SUBJECT: Campaign #84 - Rialta® Wheel Cover

INSTRUCTION TO PERFORM CAMPAIGN #84

Replacement of Wheel Covers on 2002 Kia Ista models

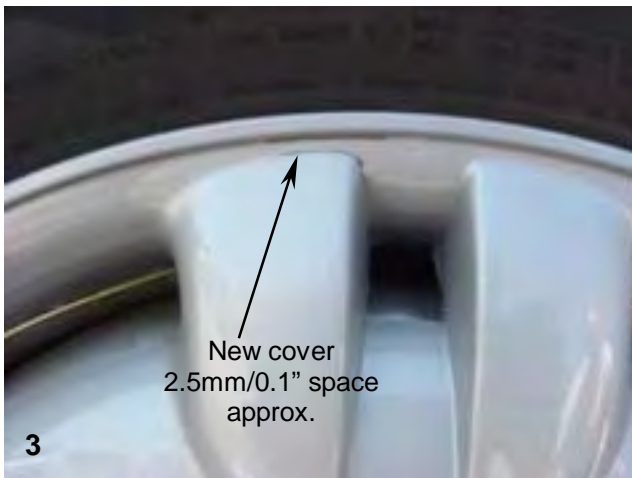
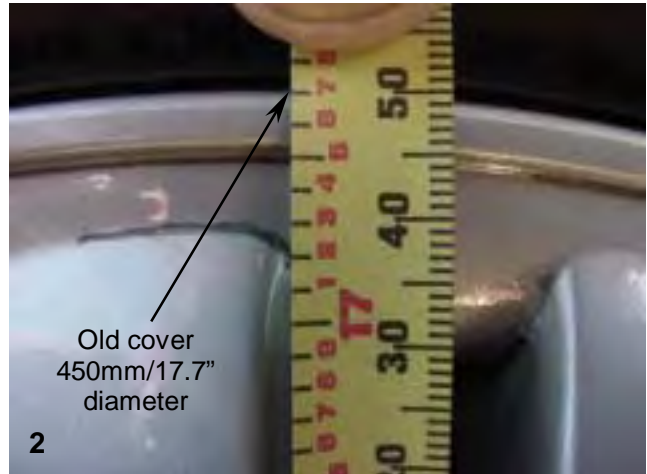
Existing wheel covers on these vehicles may rotate and cause damage to valve stems. Also, some front wheels may be equipped with rubber-mounted brass valve stems instead of rigid-mounted silver steel ones.

As you can see in photos 1 and 3, the space between the spoke tip and perimeter bead is greater on the old wheel cover than the new one. In photos 2 and 4, you will note that the old wheel covers have a larger diameter (17.7") than the new wheel covers (17.4").

1. **Replace three (3) rubber-mounted brass valve stems** on both rear wheels and the spare tire with new rigid-mounted steel valve stems and extensions supplied in parts kit.
 - **Tighten the valve stem retainer collars to 4.4-5.9 ft./lbs.**
 - **Tighten the wheel lug bolts to 105-128 ft./lbs.**
2. **Inspect the front wheel valve stems** to verify that they are rigid-mounted steel valve stems. (If any wheel on the vehicle is equipped with a rubber-mounted brass valve stem, it must be replaced with a rigid-mounted steel one.)
3. **Replace all four (4) wheel covers** with new covers supplied in parts kit.
4. **Retain all parts for SDM scrapping.** (Failure to submit replaced parts for scrapping may interfere with warranty labor recovery and may be subject to federal penalties.)
